NINE MILE POINT NUCLEAR STATION, UNIT NO. 1

AMENDMENT TO FACILITY OPERATING LICENSE

Amendment No. 41  
License No. DPR-63

ATTACHMENT TO LICENSE AMENDMENT NO. 41

Figure-2.1.1. Flow Biased Scram and APRM Rod Block

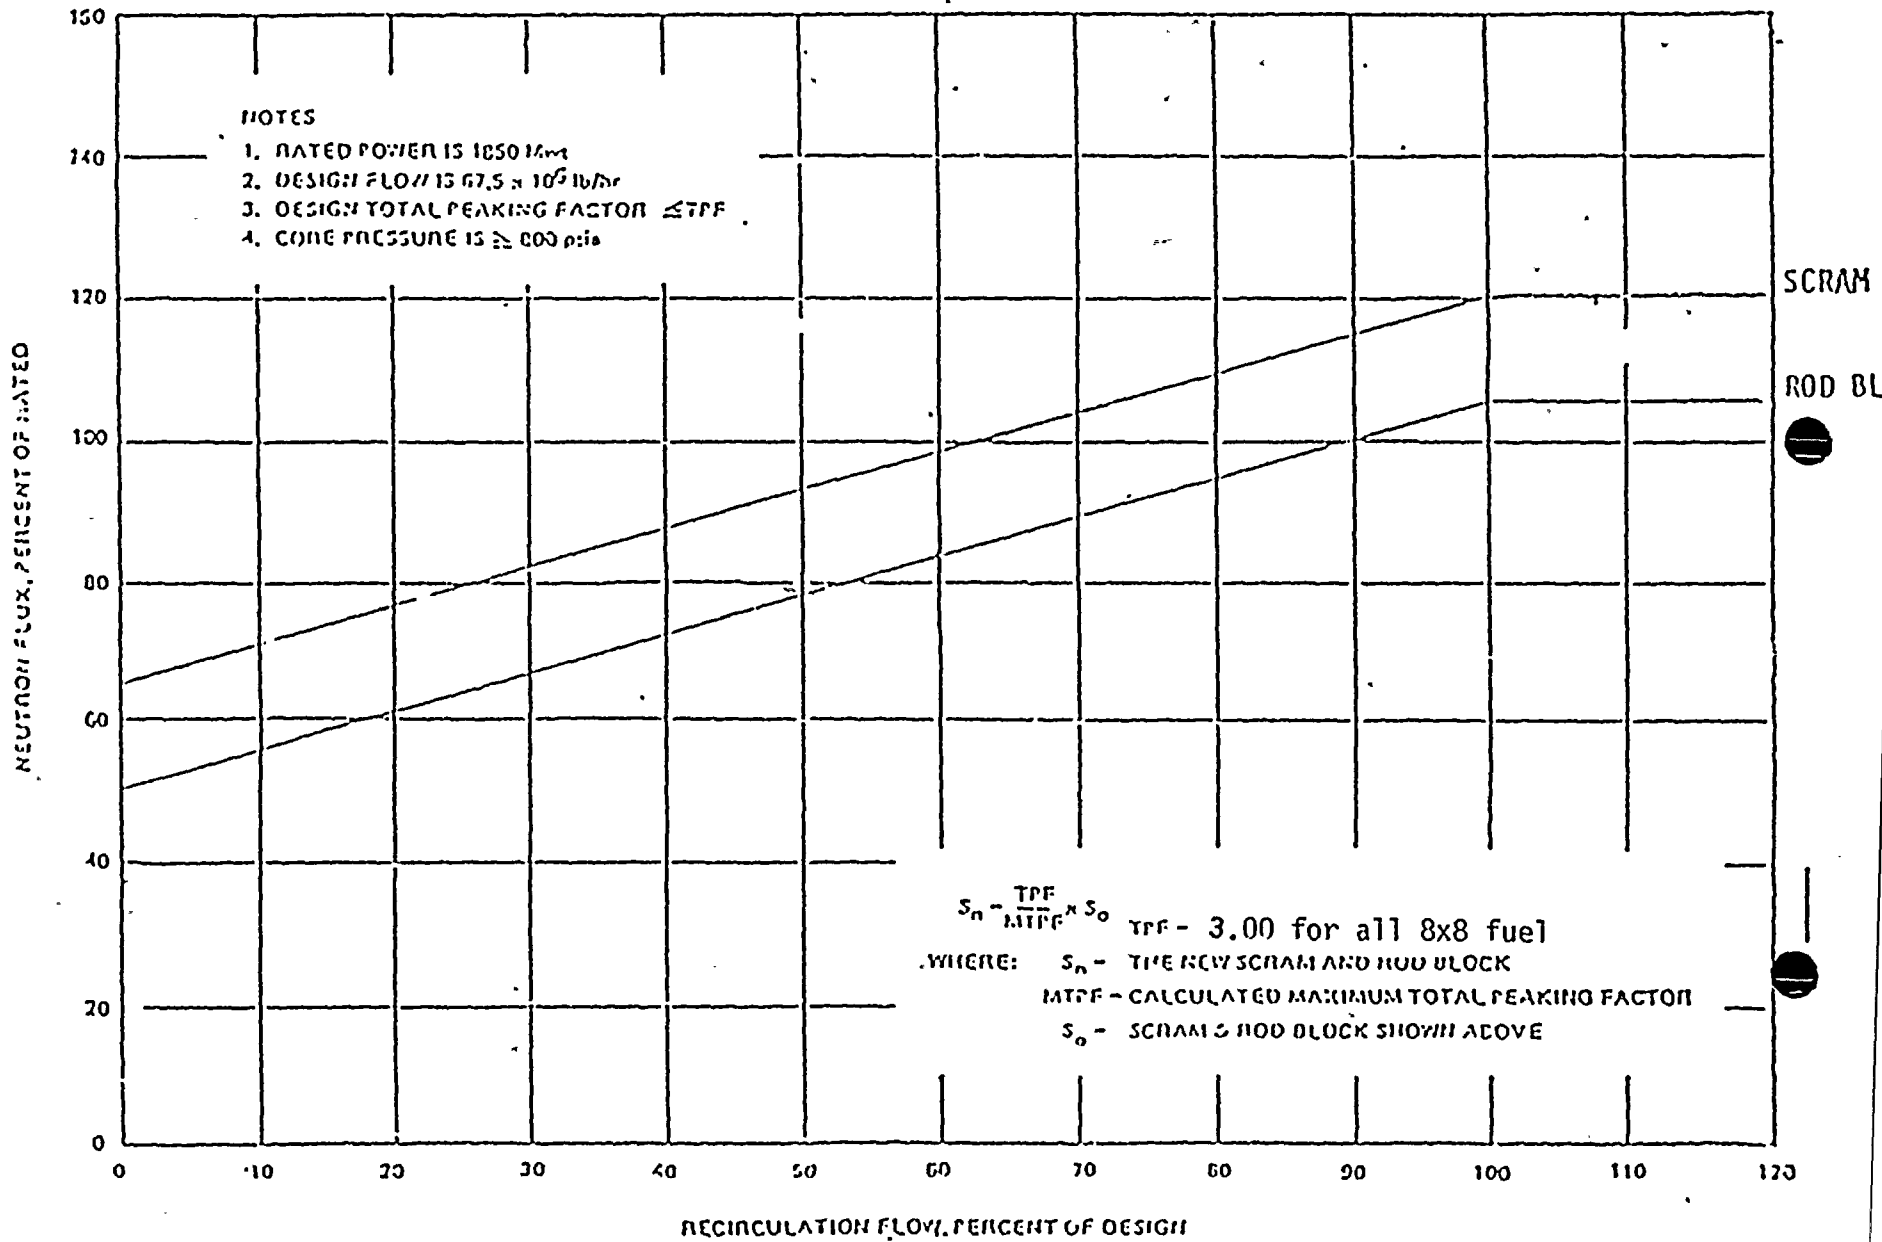
- Fuel cladding limiting safety system settings shall be as follows:
- a. The flow biased APRM scram trip settings shall be less than or equal to that shown in Figure 2.1.1.
  - b. The IRM scram trip setting shall not exceed 12% of rated neutron flux.
  - c. The reactor high pressure scram trip setting shall be  $\leq$  1000 psig.

In addition to the boiling transition limit SLCPR operation is constrained to a maximum LHGR of 13.4 kW/ft for 8x8 fuel and 13.4 kW/ft for 8x8R fuel. At 100% power this limit is reached with a Maximum Total Peaking Factor (MTPF) of 3.02 for 8x8 fuel and 3.00 for 8x8R fuel. For the case of the MTPF exceeding these values, operation is permitted only at less than 100% of rated thermal power and only with reduced APRM scram settings as required by Specification 2.1.2.a. (In cases where for a short period the total peaking factor was above 3.02 for 8x8 fuel and 3.00 for 8x8R fuel the equation in Figure 2.1.1 will be used to adjust the flow biased scram and APRM rod block set points.

Figure S.1.7.aa LIMITING POWER FLOW LINE

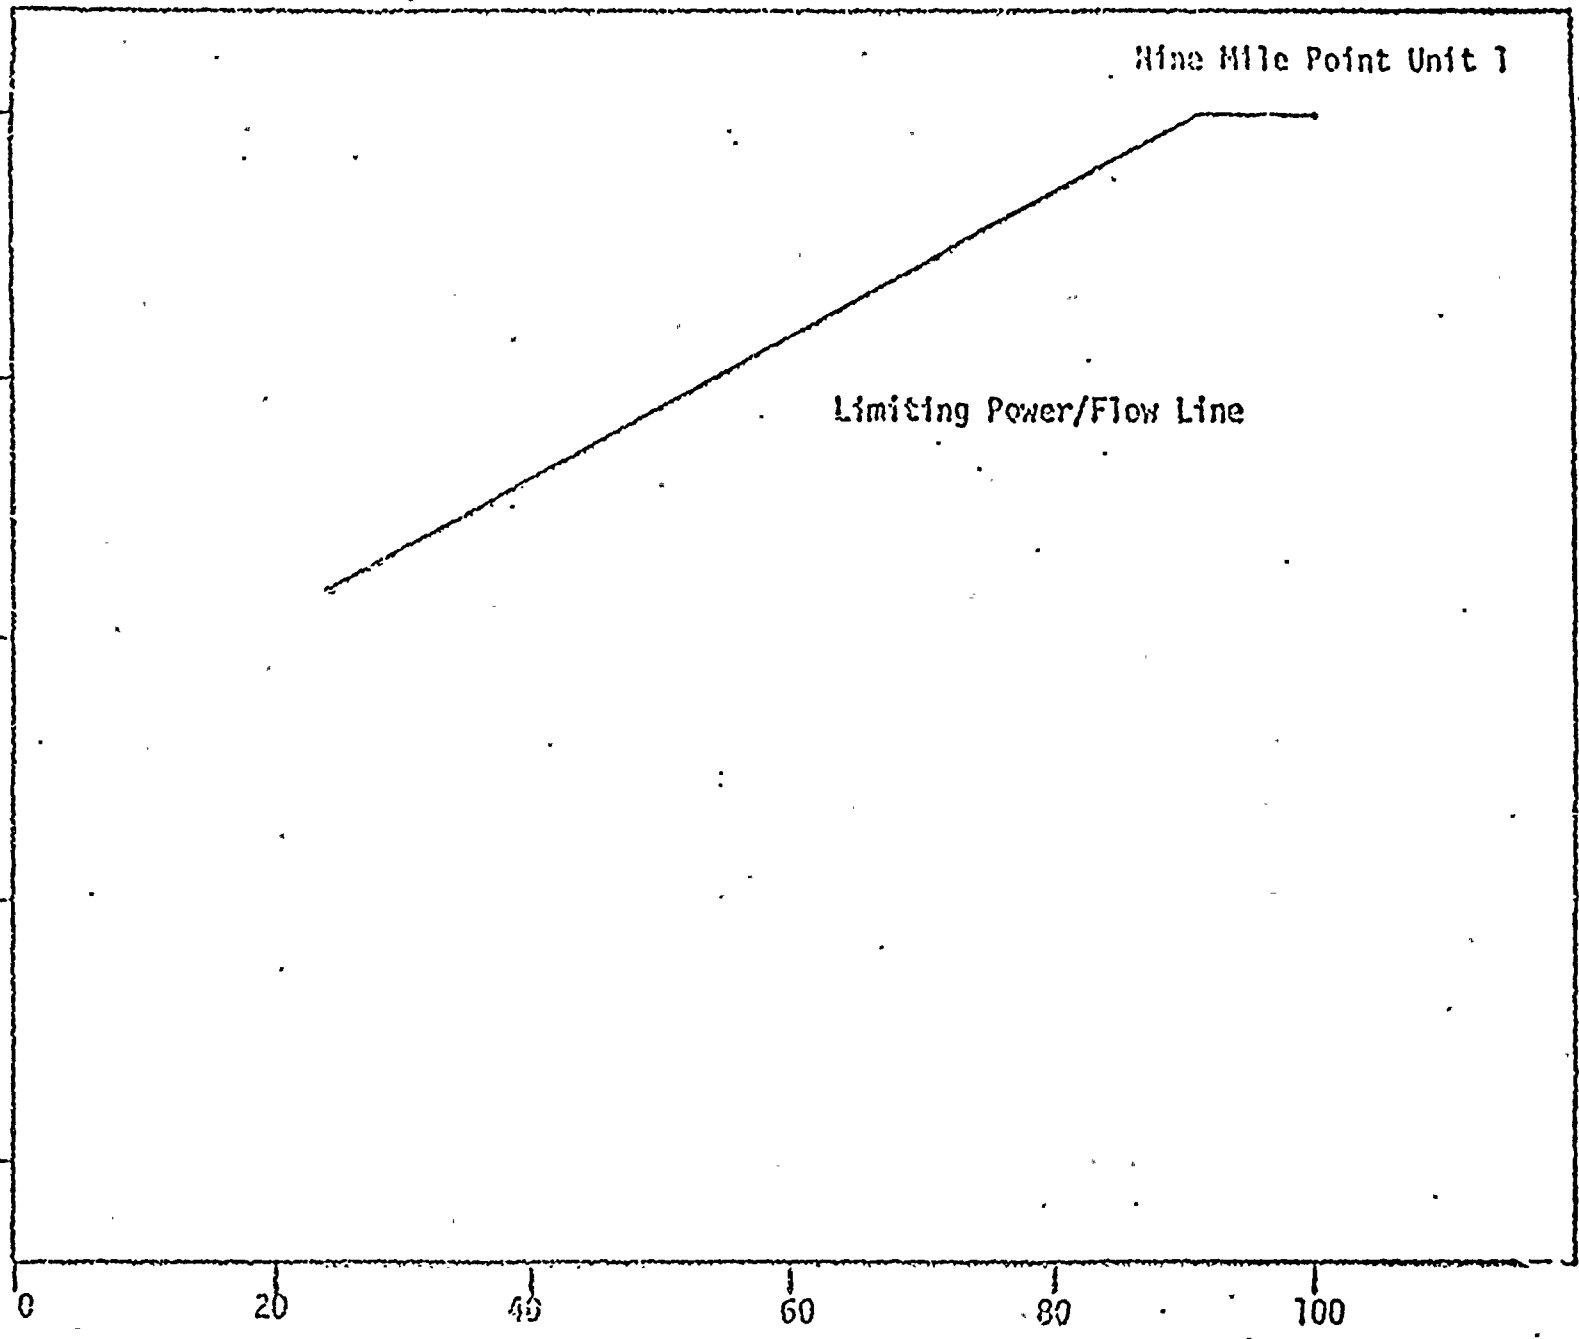
The power/flow relationship shall not exceed the limiting values shown in Figure 3.1.7.aa.

When operating with three recirculation loops in operation and the two remaining loops isolated, the reactor may operate at 100 percent of full licensed power in accordance with Figure 3.1.7aa and an APLHGR not to exceed 96 percent of the limiting values shown in Figures 3.1.7a, 3.1.7b and 3.1.7c, provided conditions 1 and 2 above are met for the isolated loops. If these conditions are not met, core power shall be restricted to 90.5 percent of full licensed power.
